**Contract No. 18-07 - CMP Storm Sewer Rehabilitation**

**Addendum Number: 1**  
**October 4, 2018**

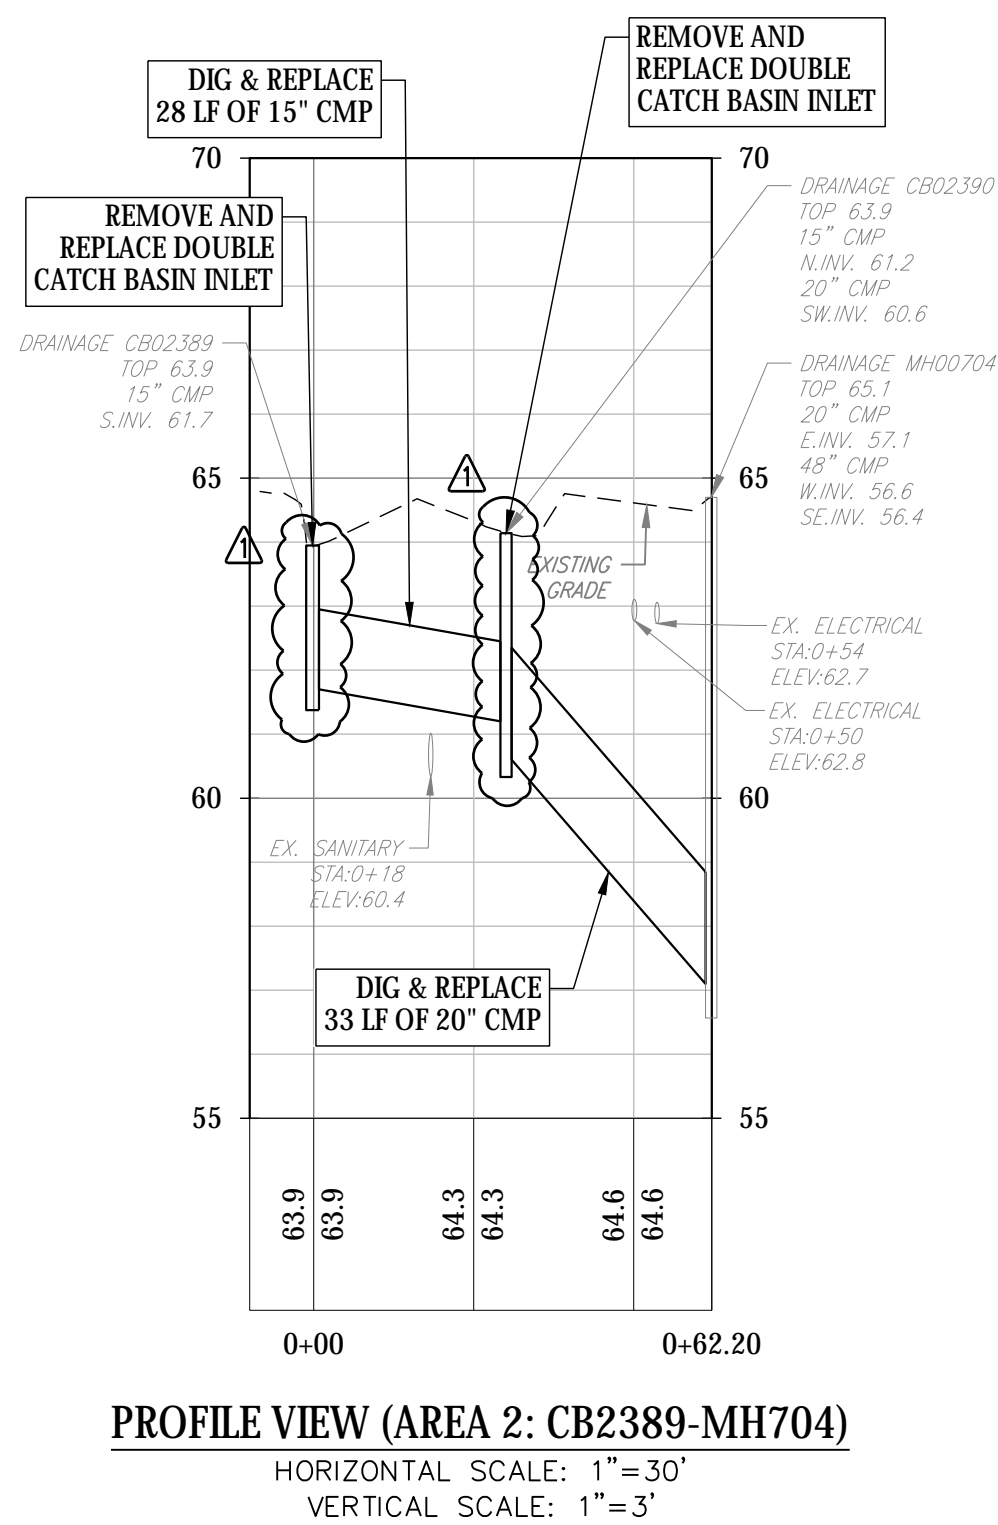
- A. **Will the City be providing a list of non-mandatory pre-bid attendees?**  
The Pre-Bid meeting sign in sheet is attached to this addendum
- B. **Are the catch basins to be repaired or replaced?**  
All catch basins noted on the plans to be removed and replaced shall be replaced with new precast single or double catch basin accordingly. The Profile Views on Drawing C201 have been revised to include annotations regarding the removal and replacement of the catch basins. See revised Drawing C201 attached.
- C. **Clarify the length of the 48" CMP shown to be removed and replaced on drawing C103.**  
The work items schedule has been revised to be consistent with the pipe length and material annotation on the plan view for Ranch Court. See revised Drawing C103 attached.
